REFERENCE: DRAINAGE PLAN FOR CHECKER AUTOWORKS AT 5800 CENTRAL AVENUE, SE (K-18/D23)

This letter is a request for an urgent review of proposed changes to the referenced drainage plan which you approved by letter dated September 28, 1989.

RE: REVISED DRAINAGE PLAN FOR CHECKER AUTOWORKS @
5800 CENTRAL AVENUE, SE (K-18/D28) REVISION DATED 12/7/89

GRADING AND DRAINAGE PLAN
CHECKER AUTOWORKS STORE
5800 CENTRAL AVE SE
(CORNER OF ALVARADO DR AND CENTRAL AVE SE)

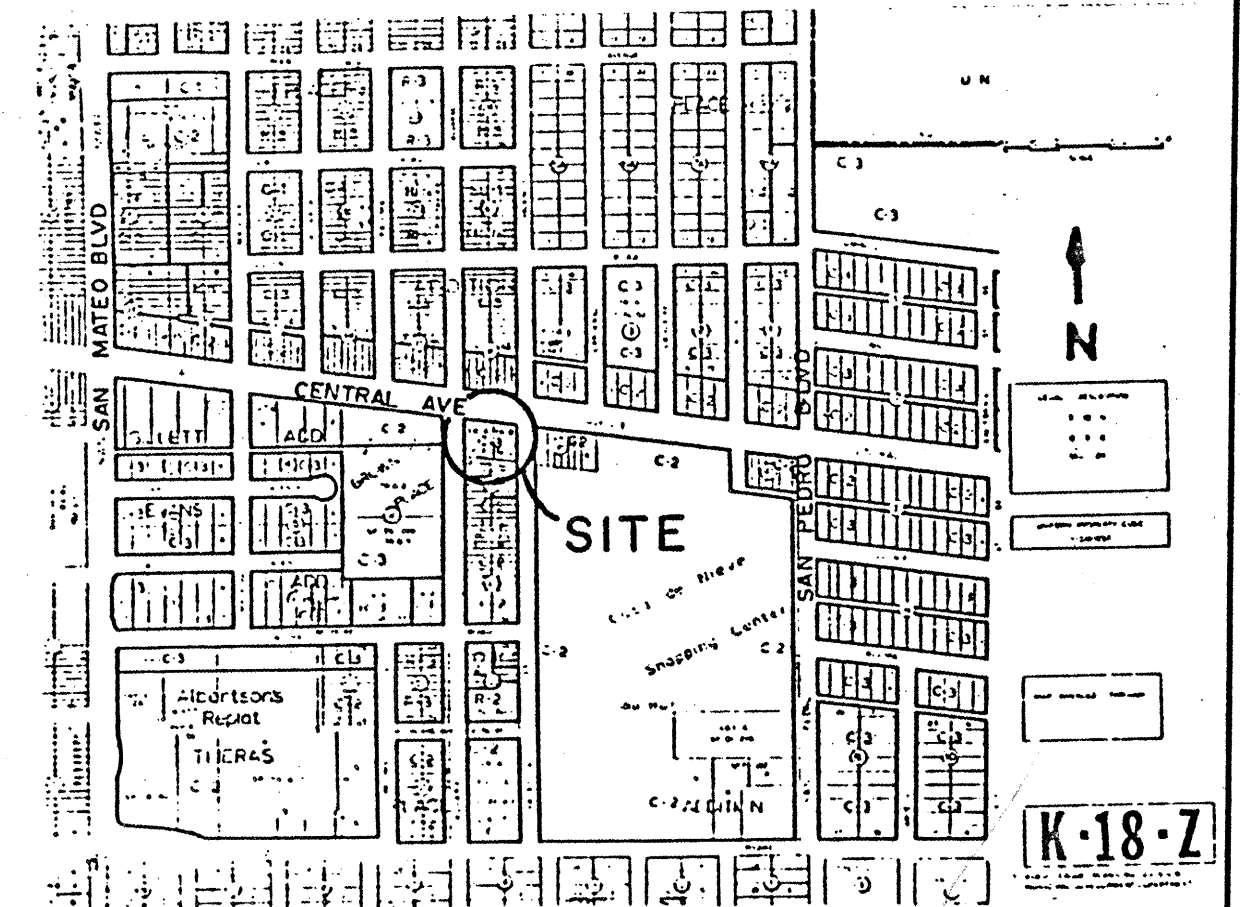
Construction is well underway on the proposed building. The finished floor elevation was erroneously set at 0.5 feet below the approved elevation. The proposed revisions show the present as-built elevation, and adjust the parking and other drainage and grading elevations.

On behalf of the owner and contractor, I urgently request your review and comment on the proposed revisions as soon as possible. For your information, there is no overall change in the drainage pattern, mostly just a change in the degree of slope.

REVISION I LOWER FFE 0.5' ADJUST PAVING
DECEMBER 7, 1989 BY M.R. KORTUM

Based on the information provided on your resubmittal of December 17, 1989, revisions as indicated are acceptable.

INSPECTION REQUESTED DATE: 2-26-90
APPROVED DATE: 2-27-90 REJECTED DATE:
S.O. APPROVAL DATE:
SURVEY DATE:
HYDROLOGY BOOK NO. / PAGE NO.
SURVEYED BY:
COMMENTS: PLANS REFLECT AS-BUILT ELEVATIONS PER LETTER DATED 12-7-89
